ADDENDUM NO. 2

Union Village Pool, Landscape, Bathhouse and Pavilion Project Re-Bid

DATE: November 6, 2025

ELECTRICAL - LIGHTING PLAN

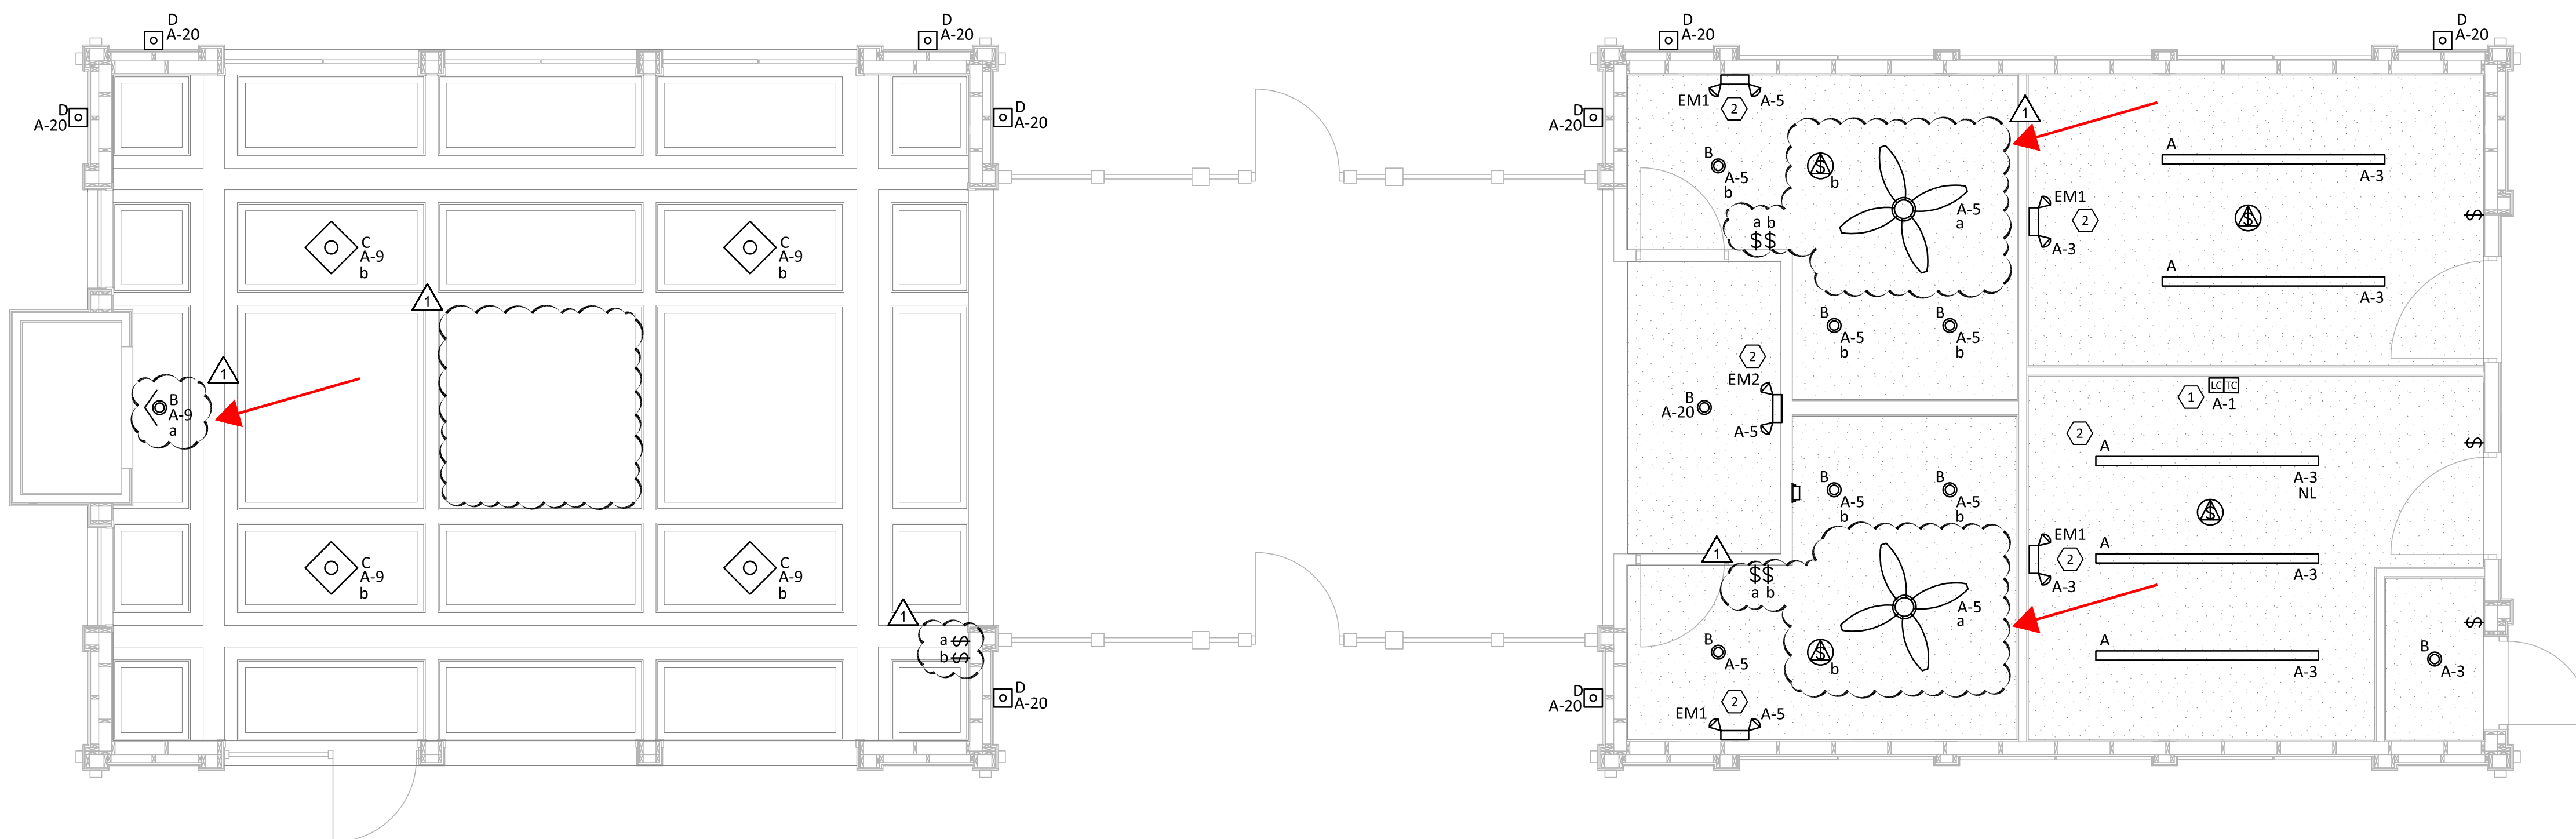
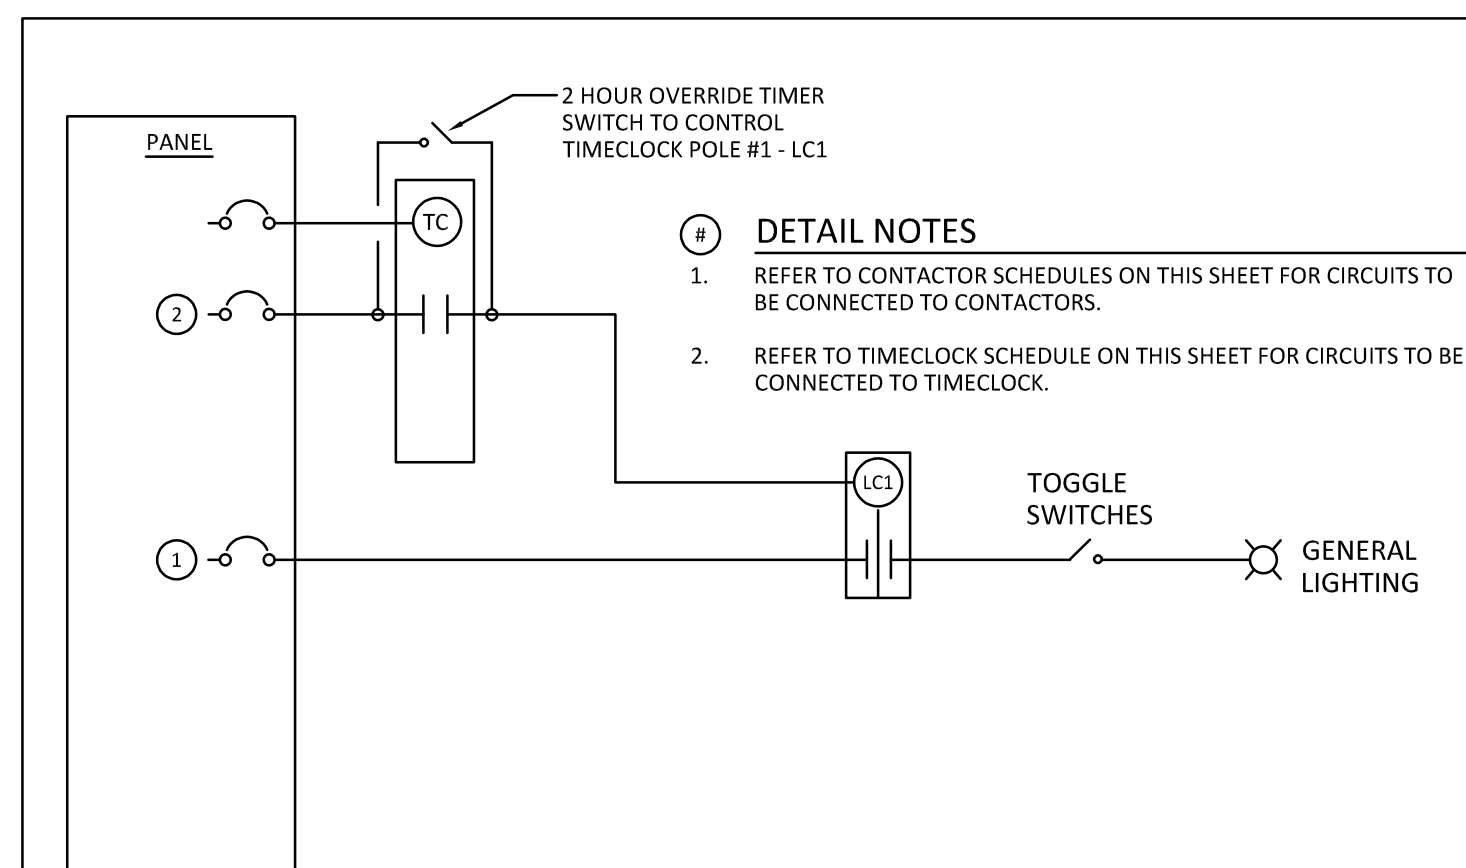
1. Owner furnished Owner installed materials are both listed as cameras and fob scans. I am understanding that these are Owner provided materials, but please clarify if these are to be Owner or Contractor installed. **Answered:** Yes, Owner furnished and owner installed for cameras and fob scans.
2. Insulation is not shown above ceiling in the main building. Insulation is shown in the walls. Is insulation to be included above ceiling or should that be excluded? **Answered:** Insulation excluded from ceiling.
3. Sheet E2.00 for the electrical lighting plan has triangle with a #1 and a clouded areas but cannot find notes to clarify requirements. [Sheet is attached to this Addendum.] **Answered:** Clouded area are revisions prior to the original bid. We added fans. Price as shown.
